UNITED STATES  
NUCLEAR REGULATORY COMMISSION

SUBJECT: SUMMARY OF MEETING BETWEEN THE U.S. NUCLEAR REGULATORY COMMISSION AND THE BWOG REPRESENTATIVES TO DISCUSS THEIR PROPOSED RESOLUTION OF STAFF OPEN ITEMS IN THE DRAFT SAFETY EVALUATION FOR BAW-2244, "DEMONSTRATION OF MANAGEMENT OF AGING EFFECTS FOR THE PRESSURIZER". (TAC NOS. M 96277, M96278, & M 96279).

B&WOG GLRP  
Pressurizer Report (BAW-2244)

Responses to  
Draft Safety Evaluation Open Issues  
November 6, 1996

## HEATER BUNDLE PRESSURE BOUNDARY DETAILS

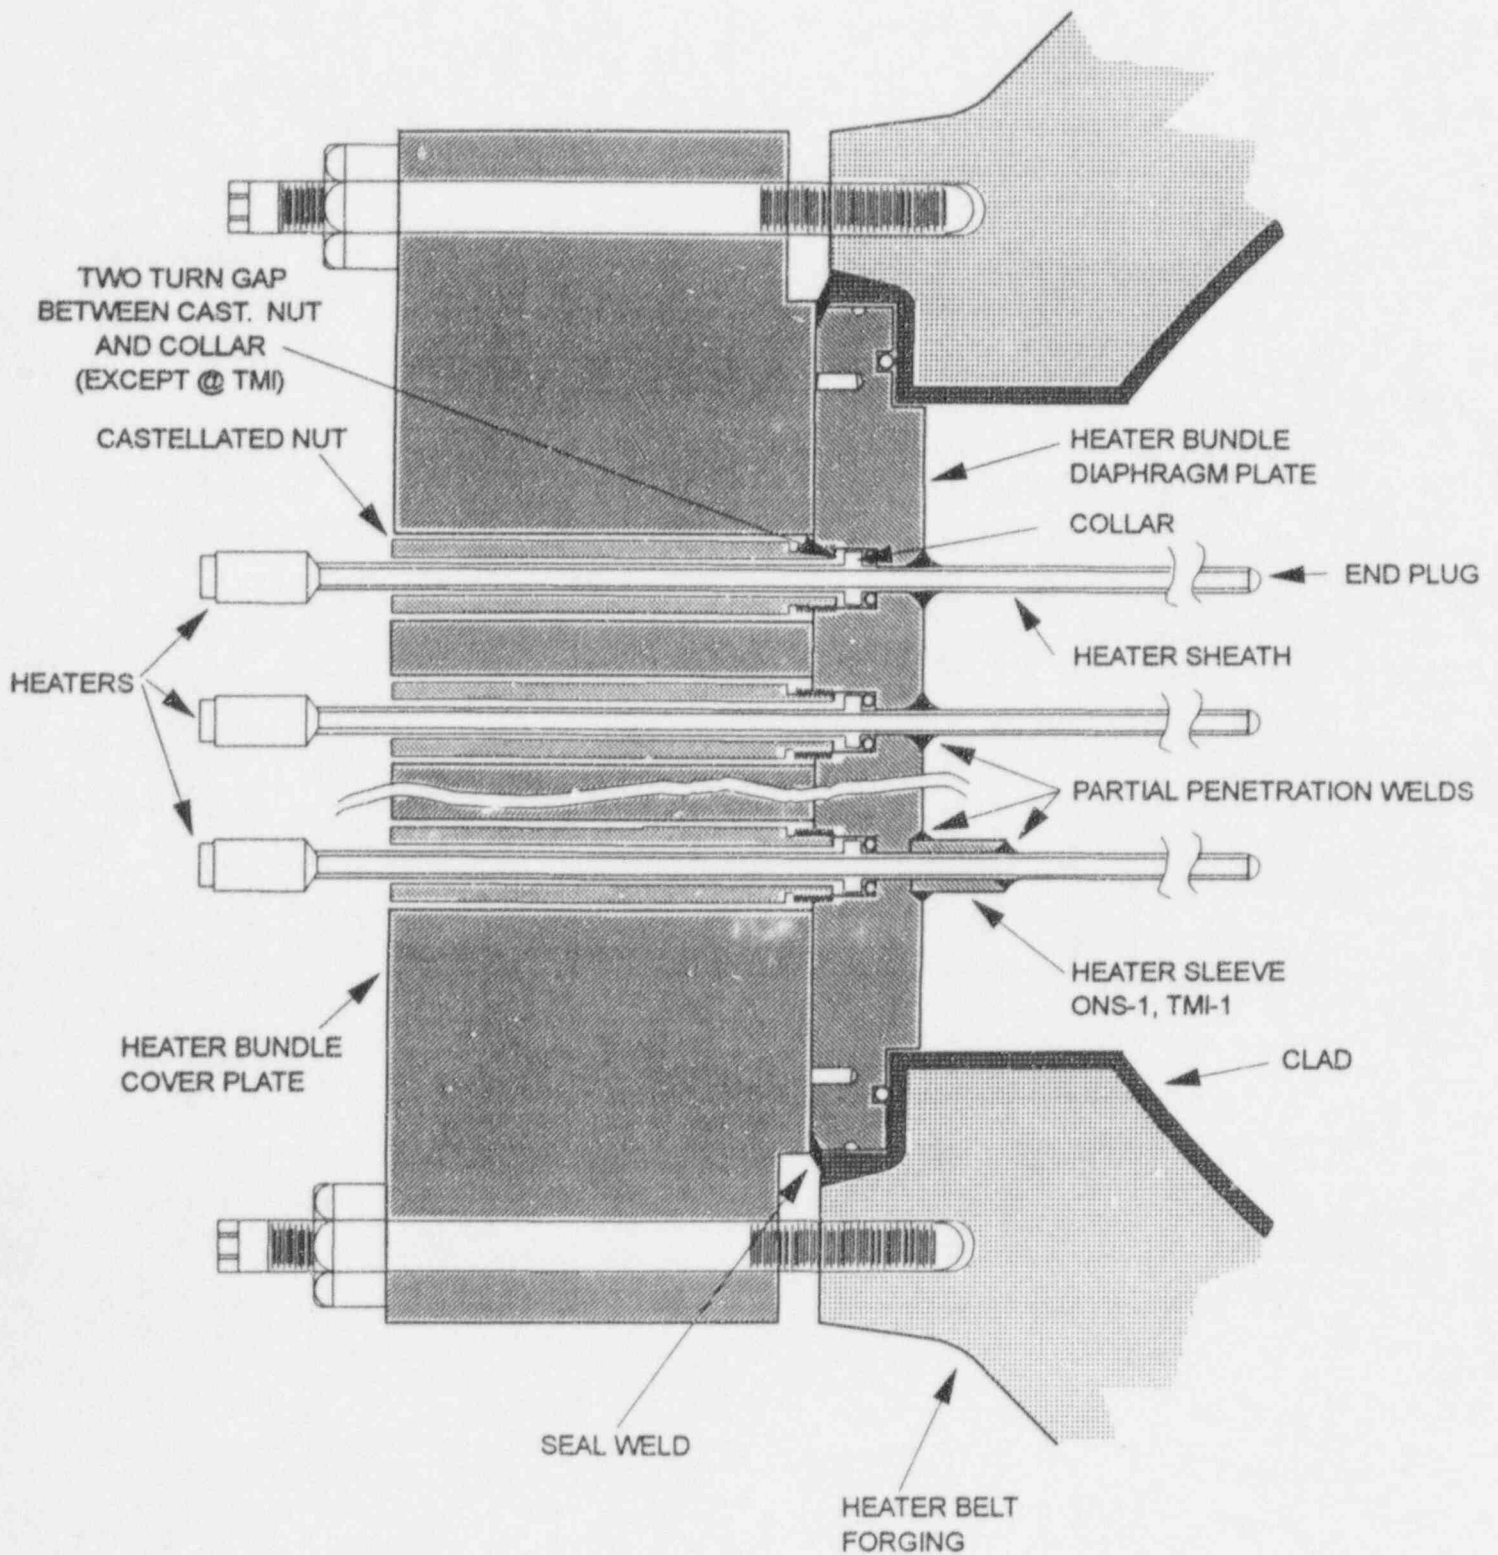
On the issue of pressurizer heater partial penetration welds, the B&WOG stated that they perform a Category B-P examination because the welds are part of the bolted closure for the heater bundle. Additionally, they stated that the B-P inspection is equivalent to B-E. The staff questioned whether the B-P inspection for the heater bundle really is a focused look for leakage, since the heater bundle may not be considered a bolted connection due to the existence of the seal weld modification. The B&WOG committed to confirming that the B-P inspection that is actually performed is in fact a focused leakage inspection around the heater bundle and is equivalent to B-E. The staff still expressed their belief that a more intrusive inspection of the condition of the heater partial penetration welds, at least on a one time

- Category B-E an applicable inspection.
- Staff does not believe that B&W heater welds substantially different from other vendors.
- A more intrusive exam necessary along with Category B-E.

basis, is appropriate to determine their susceptibility to cracking. The B&WOG agreed to consider committing to a one-time inspection of these welds in the course of the original operating term of a B&W plant when a replacement of a heater bundle is necessary.

- Category B-P performed since part of bolted closure.
- Category B-P equivalent or superior to BE.
- 1993 Section XI Addenda recognizes duplicity and eliminates Category B-E.
- B&W design different from other vendors; replacement bundles versus individual heater nozzle welds.
- Inspection requires heater bundle removal. Leads to increase in critical path time, radiation dose, and cost.
- Examination is a hardship, not justifiable.
- Category B-P in concert with leakage detection adequate.

- If welds fail, leakage will be detected. Structural integrity of bolted closure will not be compromised.
- Category B-P in concert with leakage detection adequate.
- Closed.
